Final Environmental Impact Report
EEA # 16586

Hudson Solid Waste Transfer Station and Recycling Facility

October 15, 2024

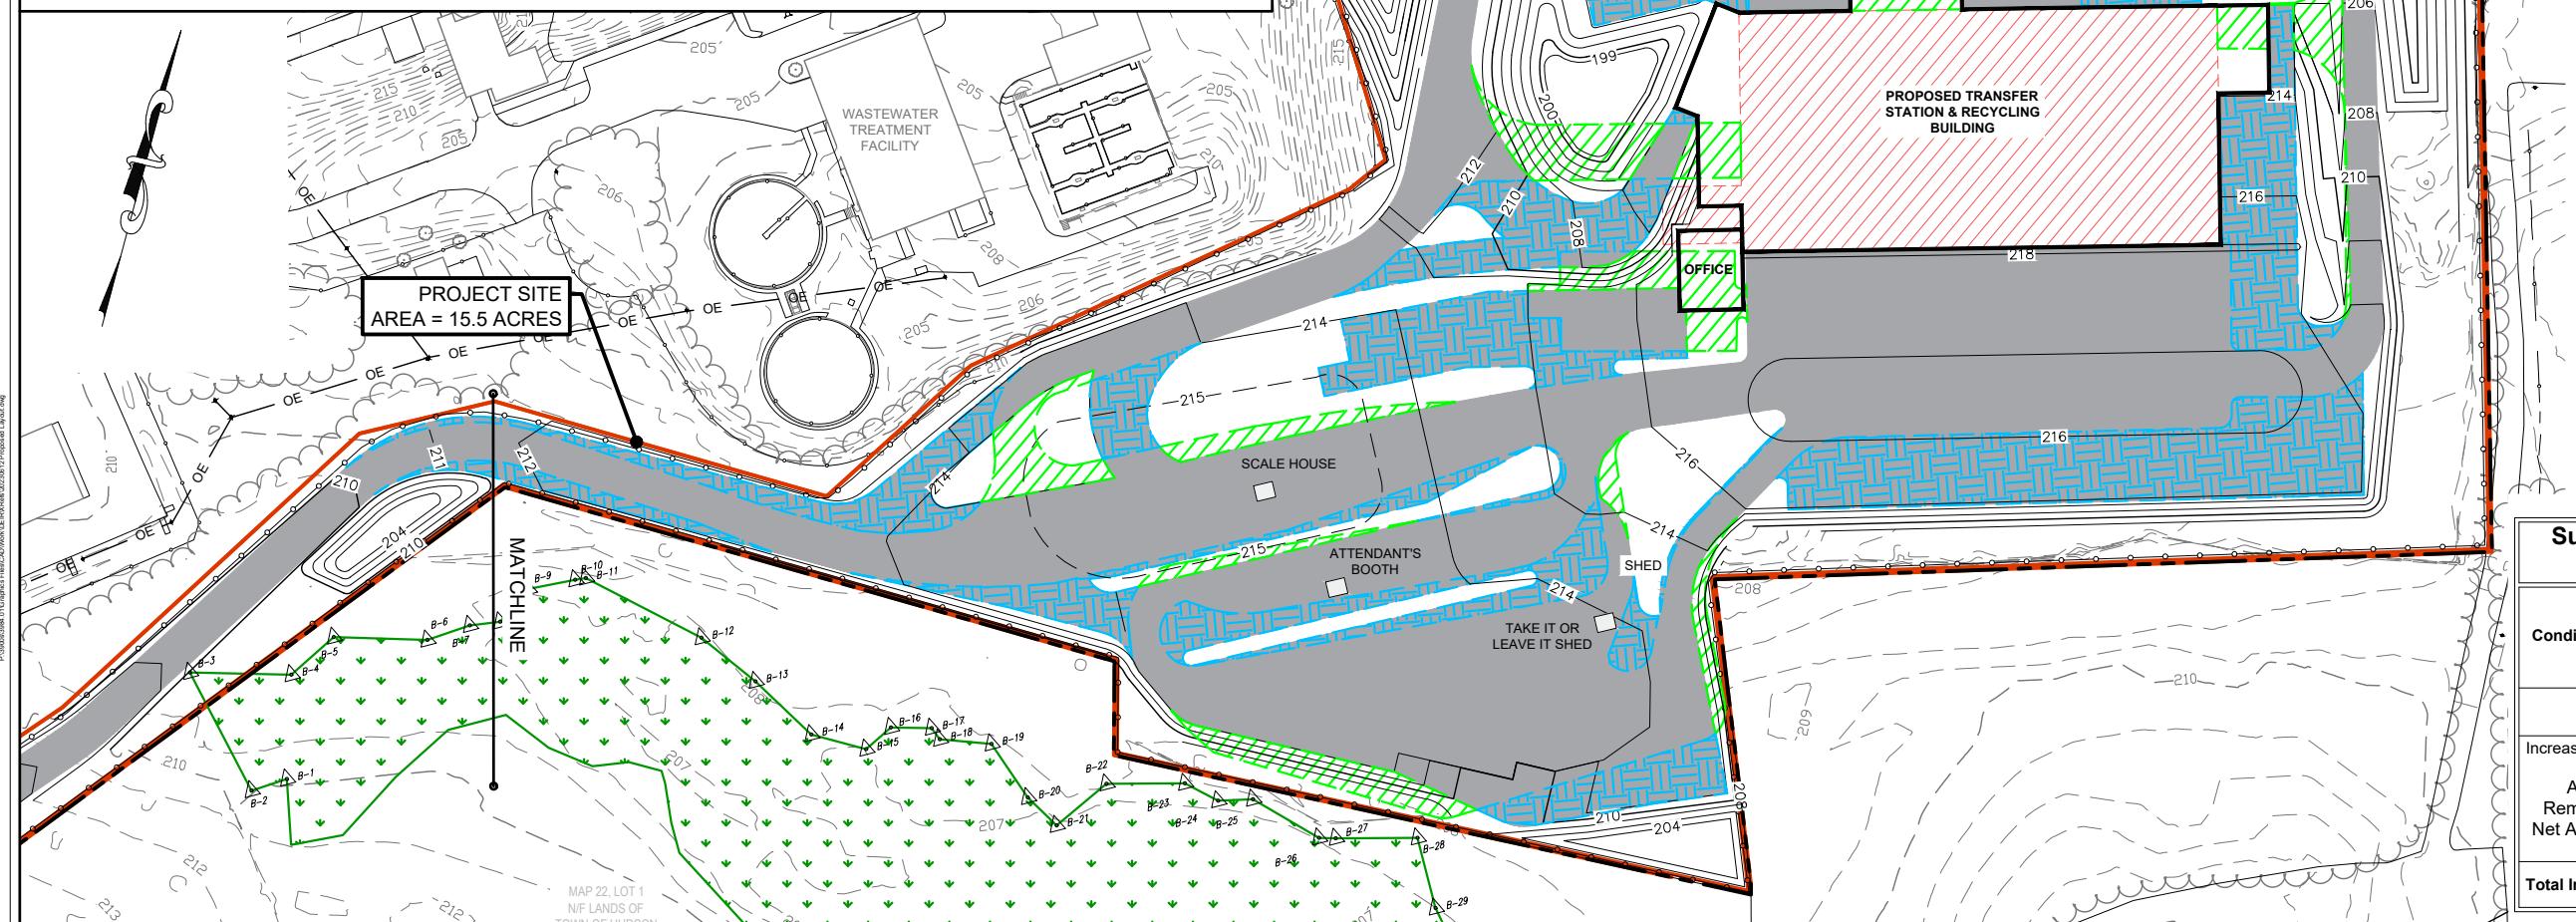
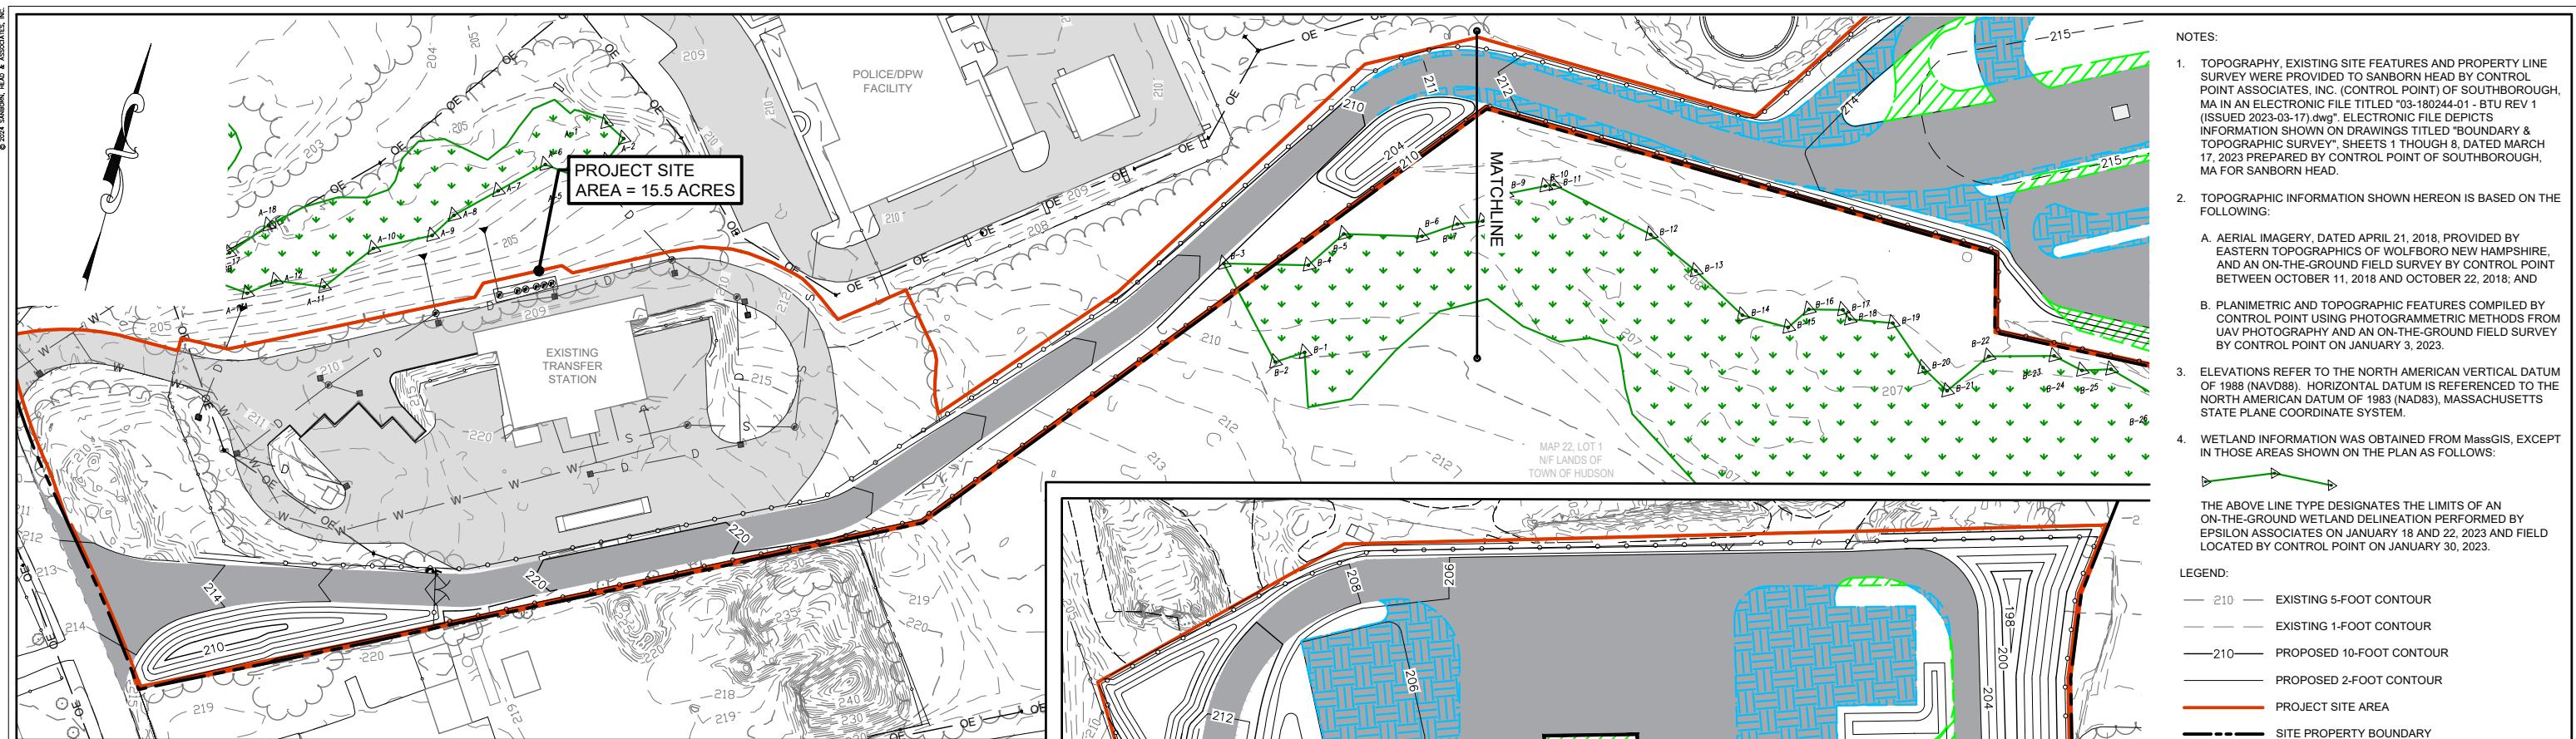
The DEIR Certificate included a comment from the MEPA Office requesting clarification on the extent of impervious surface increase associated with the Project, noting that the total amount of pavement increased from 5.3 acres to 7 acres between the ENF and DEIR filings. This increased pavement area that occurred between filings is described in Section 1.3.3 of the DEIR and reflects the results of further design development activities that occurred between the ENF and DEIR filings. Specifically, proposed access roads and paved areas were refined to accommodate vehicle access to and movement within the proposed Residential Drop-off Area (RDOA) and vehicle access and movement in and around the Transfer Station & Recycling Building. Pavement areas were also refined to accommodate empty trailer storage, temporary full trailer vehicle layover, and roll-off container storage. As described in Section 1.3.3 of the DEIR, the results of these activities led to the following changes to the limits of pavement shown in the ENF:

The adjustments to the pavement areas itemized above result in a net increase in pavement area of 1.7 acres that will be added to the 5.3 acre change in pavement area identified in the ENF. These changes to the pavement area that occurred following the filing of the ENF are shown graphically on Figure 4-1A.

The increase in impervious surface associated with the proposed Project is the sum of the increase in pavement area plus the increase in building footprint area. This information is presented in Table 4-1 which summarizes: the pavement and building area increases as they existed at the time the ENF was filed; the incremental increase to these areas that occurred following submittal of the ENF; and the total increase in impervious area associated with the DEIR/FEIR filing.

FIGURE NUMBER: 4-1B

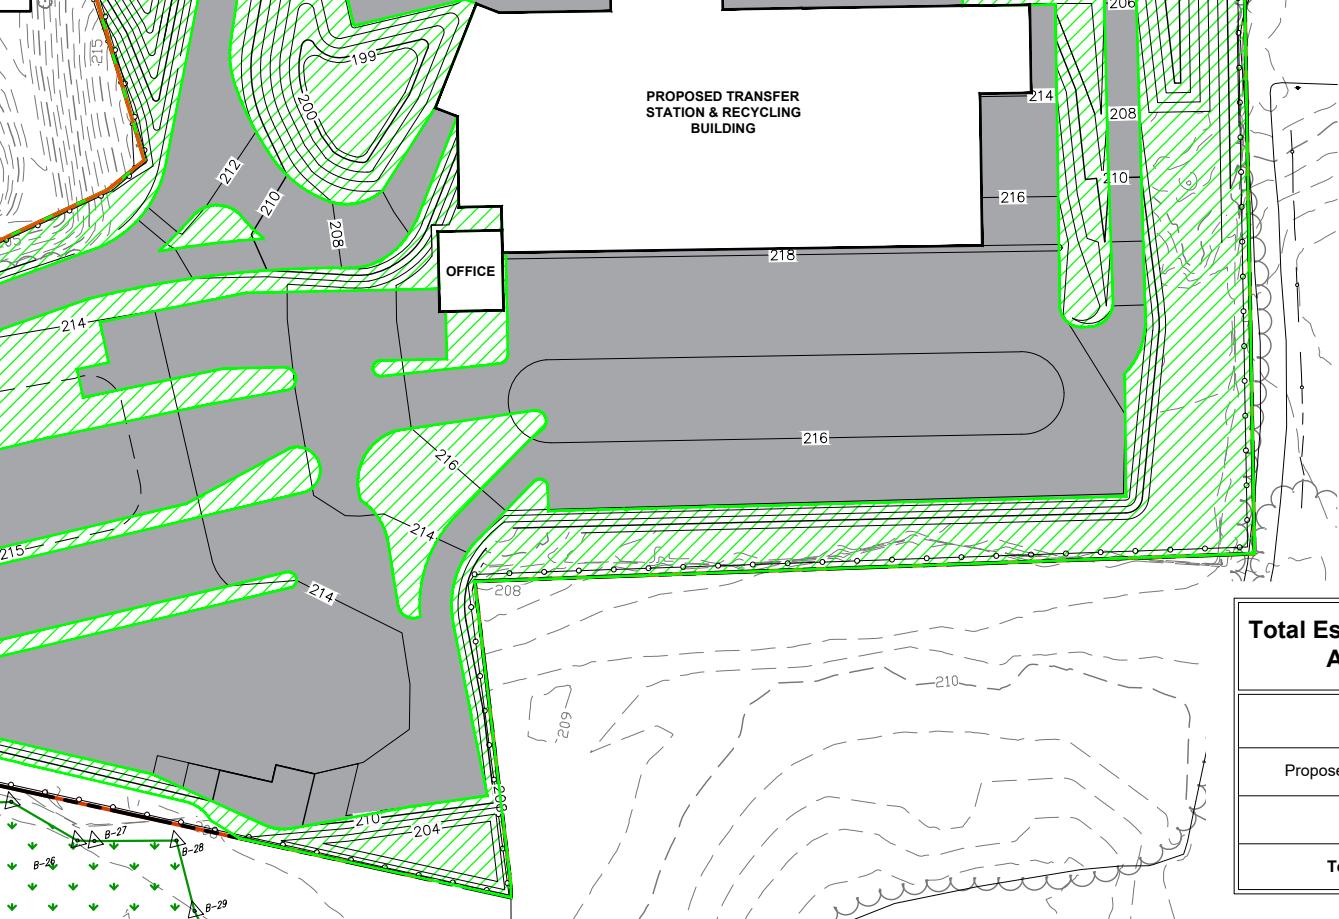
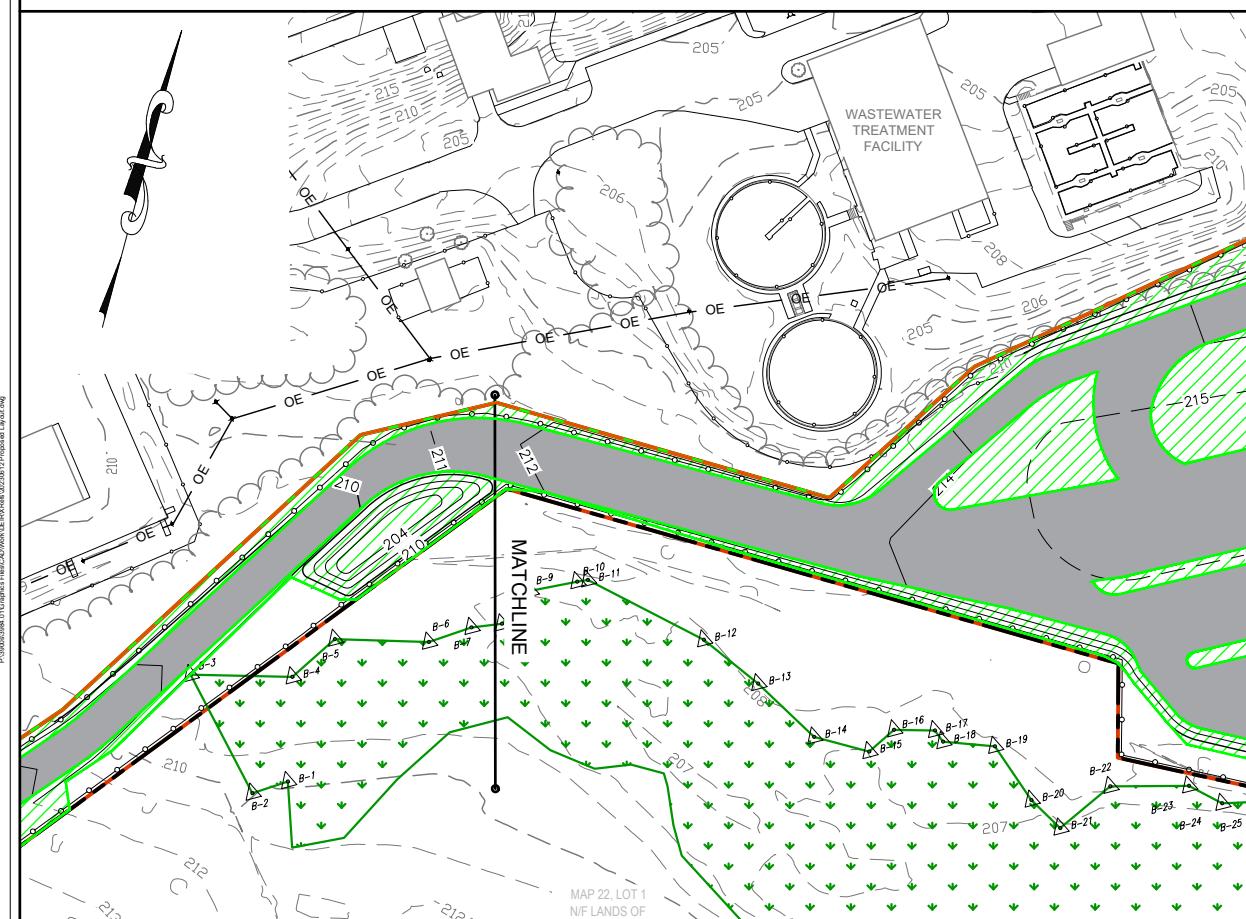
The DEIR Certificate included a comment from the MEPA Office requesting further detail on the total amount of new land alteration for the Project and an analysis of the land cover types to be altered. Section 4.3.1 provides a detailed breakdown of the amount of new land alteration associated with the Project, comparing the proposed land uses within the alteration area to the acreages provided in the ENF and how these acreages have changed since the ENF filing. Section 4.3.2 presents an analysis of the land cover types to be altered.

Altered Areas category. The increase in acreage of Other Altered Areas as represented in the DEIR/FEIR filing is approximately 4.4 acres, shown in row 4 of the Change column of the DEIR/FEIR Filing portion of Table 4-2. The locations of these Other Altered Areas are shown on Figure 4-1B.

Adding the impervious surface increase (8.2 acres) to the Other Altered Areas increase (4.4 acres) results in a total amount of new land alteration for the project of 12.6 acres. This area is itemized in Table 4-2 and shown on Figure 4-1B as a combination of the proposed Other Altered Areas, proposed pavement areas, and proposed building footprint areas.

Figure 1 Typical Pavement Deterioration Curve

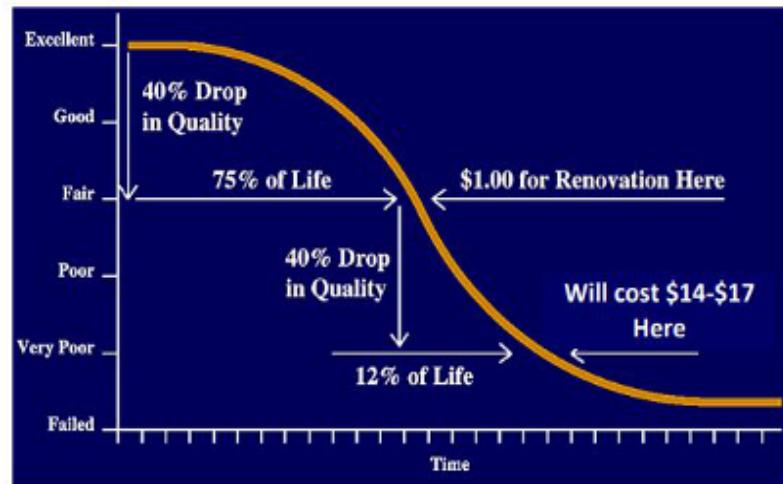
These steps are needed to inform the Hudson Department of Public Works (DPW) managerial approach to roadway deterioration and the added cost for roadway maintenance for the taxpayers of Hudson. Hudson DPW has a long term maintenance strategy. The DPW needs to know if more frequent maintenance is needed and plan for the associated cost. Referencing the 2017 Hudson Pavement Management Study, if maintenance is not done on schedule, later correction can be very expensive.

Will B-P Trucking commit to provide a pavement impact analysis for this project?

What about Reed Road, Hudson?

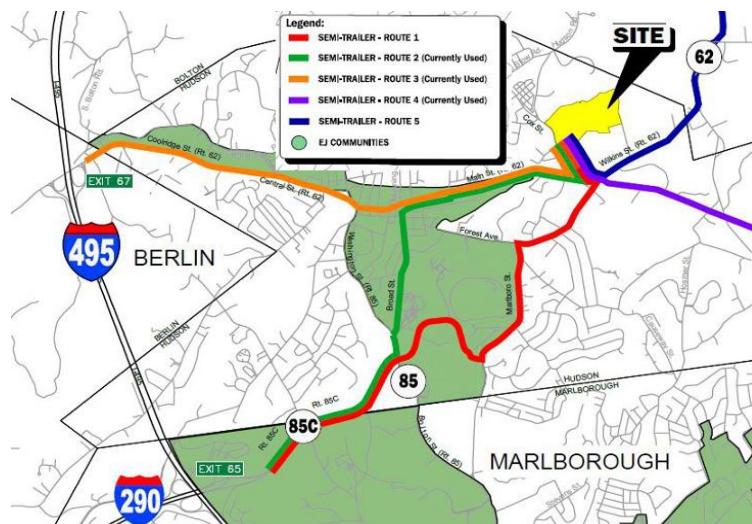
The DEIR includes proponent answers to questions originally raised during the ENF stage of the MEPA process. The question "will Reed Road be used?"

The proposed trucking routes are shown on Figure 7-8, provided in Chapter 7. As is the current case, the Proponent may use its collection vehicles to provide service to customers that are located on and within the Reed Road development area. The Proponent's semi-trailers will not use Reed Road.

Dedicated left-turn only lane (at 75 Reed Road)

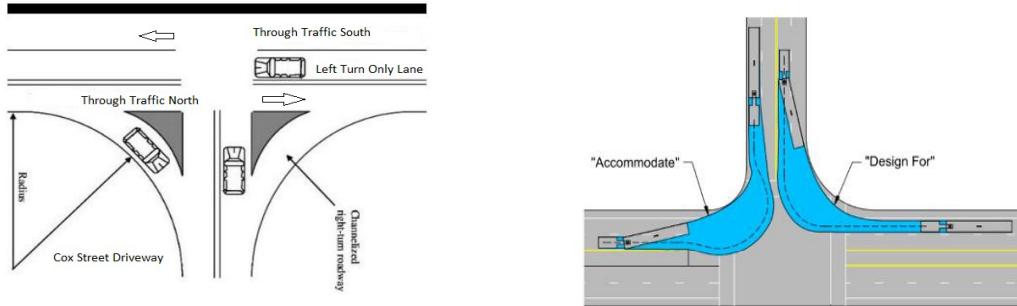
One of the MUTD "warrants", Warrant 8, seems to address the physical characteristics of the road location. The traffic increase at this driveway will be packer, roll-off truck and semi-trailers. Semi-trailers will not be allowed southbound on Cox Street. A channelized right turn northbound to accommodate semi-trailers may have merit and should be considered. Vanasse and Associates needs to be asked to include their professional review the option of the widening of Cox Street at the project driveway to include a southbound dedicated left turn lane as part of their Transportation report. Widening "designed for" the way large trucks actually turn as opposed to be able to "accommodate" turns which encroach upon other lanes. Potentially this widening study will show improved the level of service and safety of the new intersection with much less cost than installing signalized control (traffic lights) at this intersection. Widening in this case would be done on the Hudson owned side of Cox Street and would thus not involve any "taking" of residential property. In case widening of Cox Street at this location has significant merit it should become a mandatory condition for approval of the expanded capacity of the proposed transfer station for the convenience and safety of drivers using this section of Cox Street and the Town of Hudson must agree.

Will B-P Trucking engage with the Town of Hudson to recommend widening of Cox Street at JC.8 the project driveway to incorporate a dedicated left-turn only lane for southbound access?
